CMB Meeting Minutes #155

REFERENCE Project No. M544.1, Contract No. 149 Task 1-8.02

SUBJECT: Configuration Management Board Meeting # 155– Rev. No. 0

CENTRAL SUBWAY PROJECT
Project Trend/Change Control Log

CONTRACT NO.	1254R
REVISION CONTROL NO.	CL-19579
DRAWING NO.	UT-202
SHEET NO.	111
REVISION	1

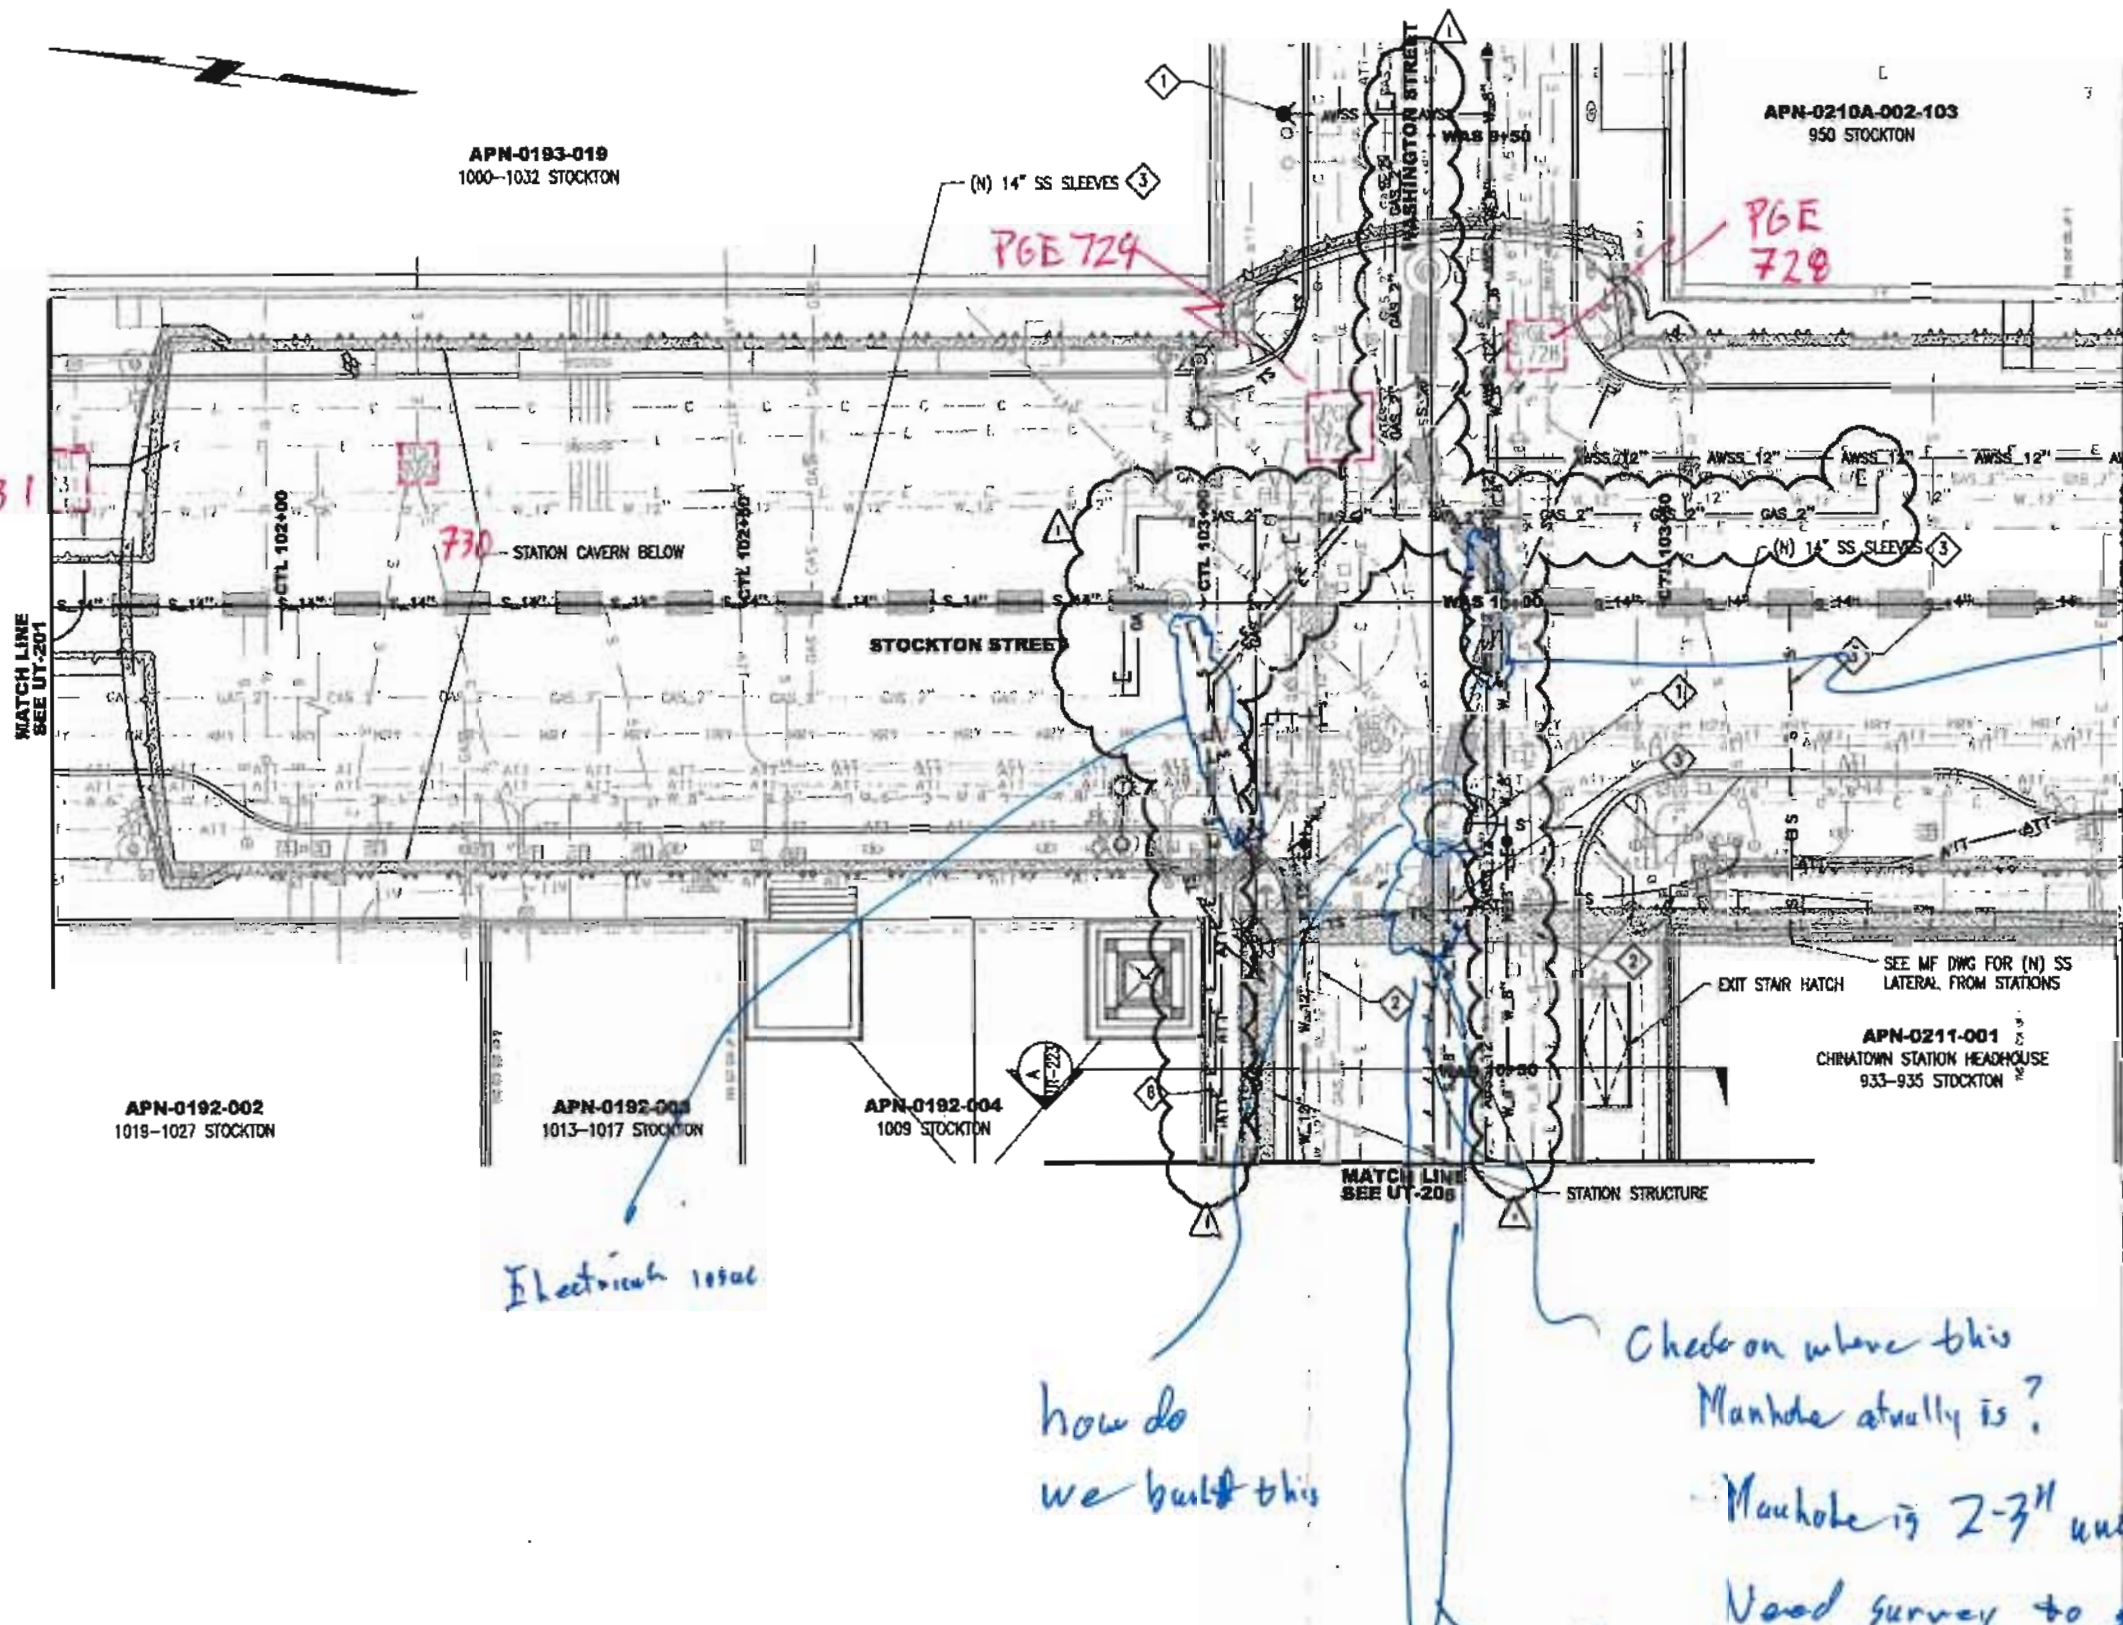
12" AWSS Line passes through sewer
Coordinate with Slip line

PROJECT: CL-19581
 SHEET: UT-204
 DATE: 12/14/2011

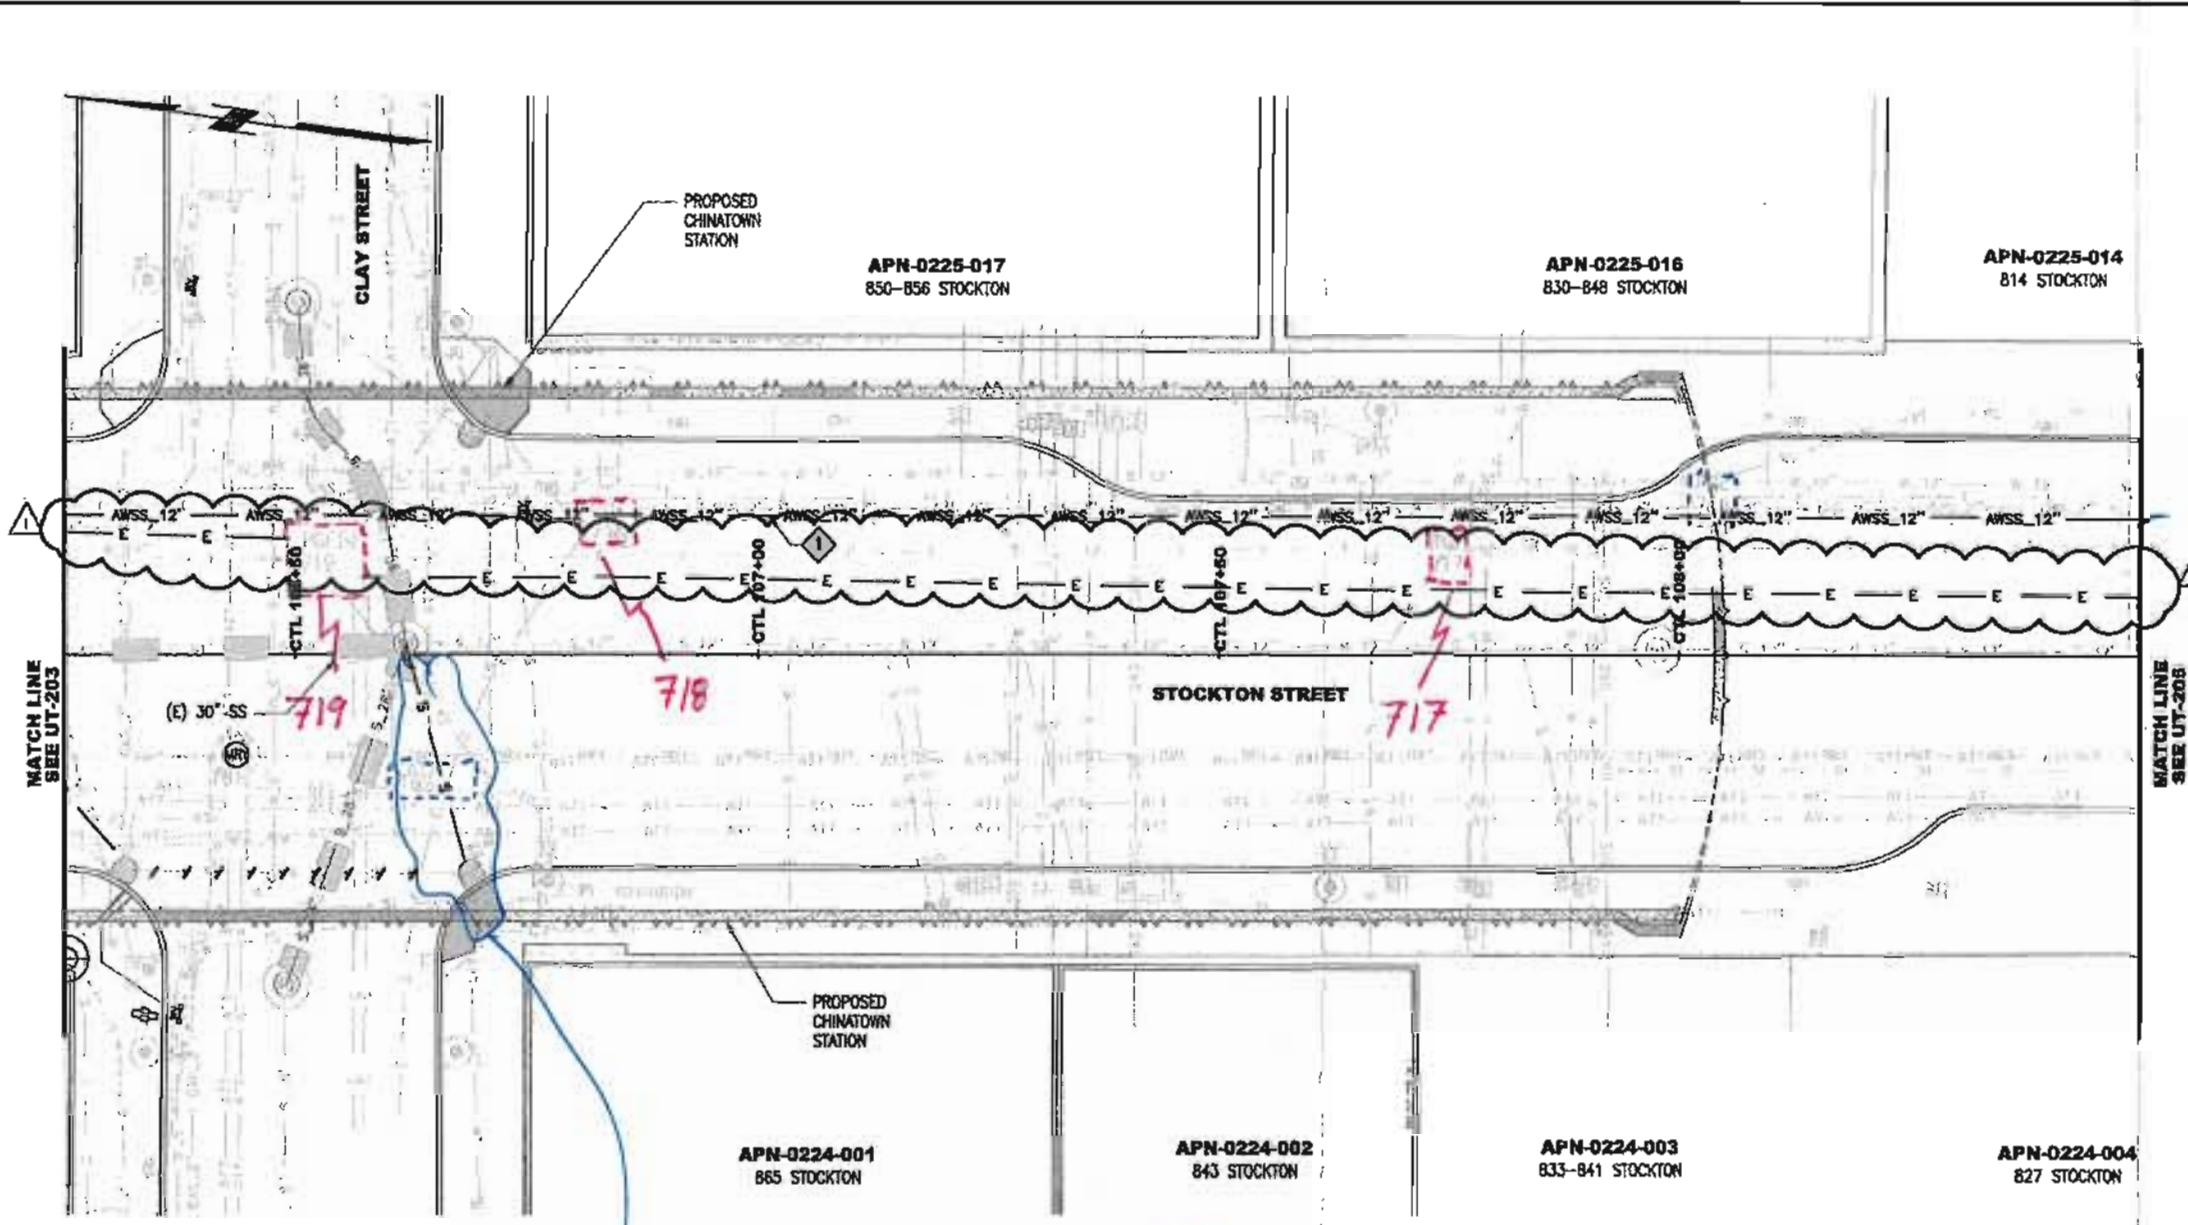
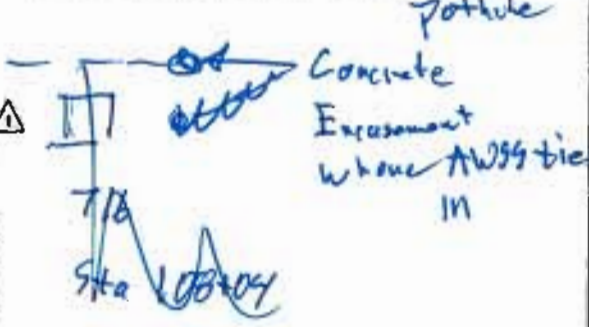
Provide concrete encasement for duct bank between the new concrete vault and the existing vault 1096. Three 4" diameter conduits were shown on the drawing JT-206, but concrete encasement was not shown.
